GAINES CHARTER TOWNSHIP
PLANNING COMMISSION – REGULAR MEETING
Township Board Room - 8555 Kalamazoo Ave. S.E. Caledonia, MI 49316

Draft Agenda

7:00 p.m. – Thursday, September 28th, 2023

Planning Commission Memo

RIGHT ELEVATION

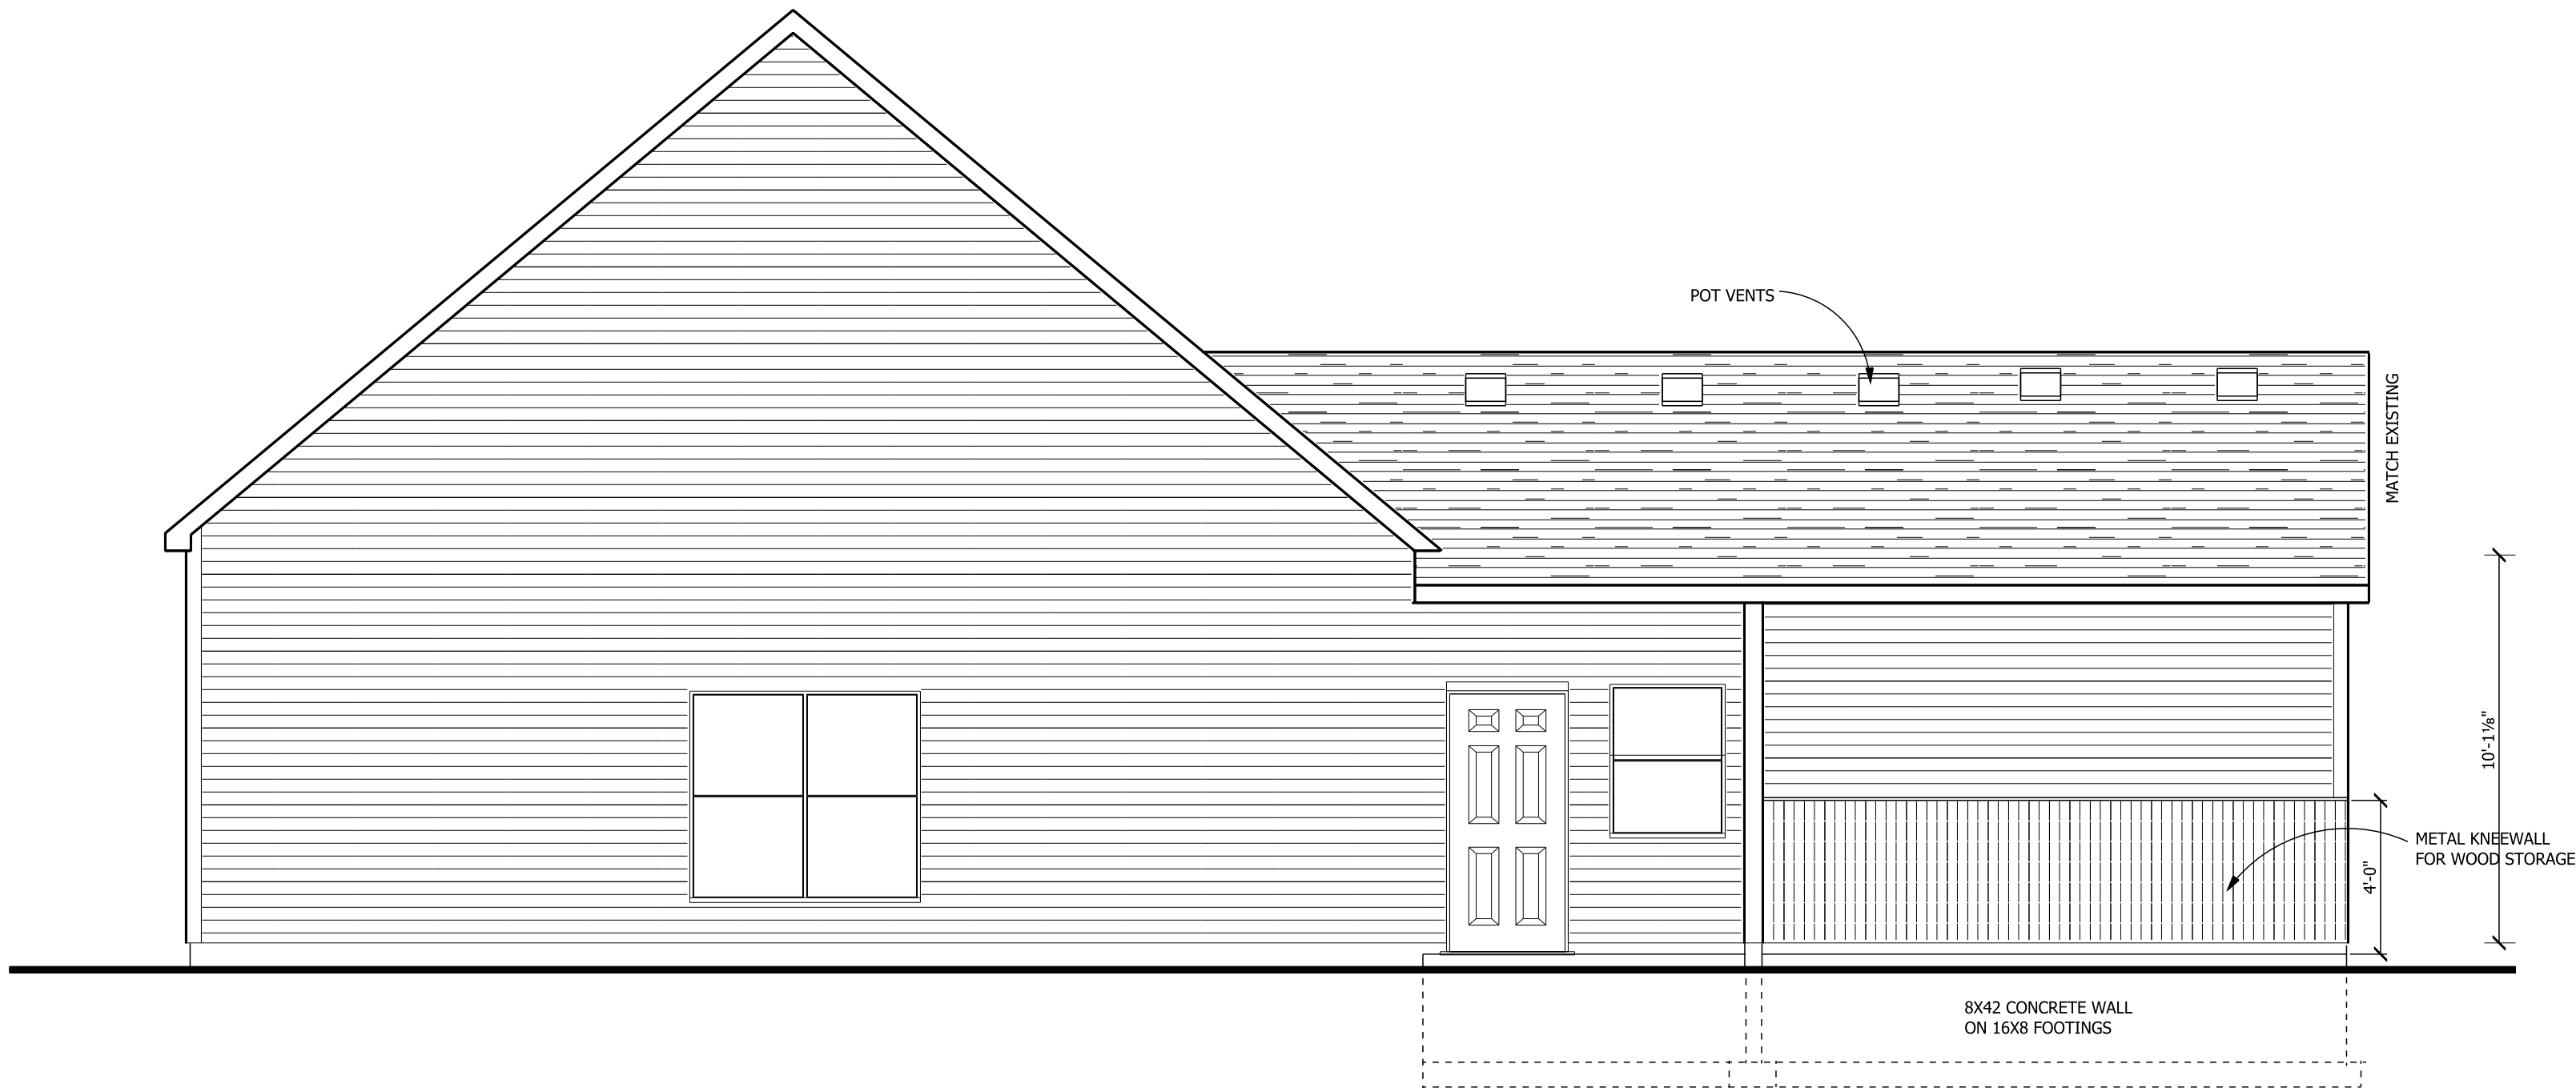
One thing to note is that there is an extended roofline for wood storage on the side of the building (see “Right Elevation” drawing in packet). Staff has confirmed with the applicant that this extended roof line is on the west side of the building and will therefore not encroach on the eight (8) foot required setback to the eastern side property line.
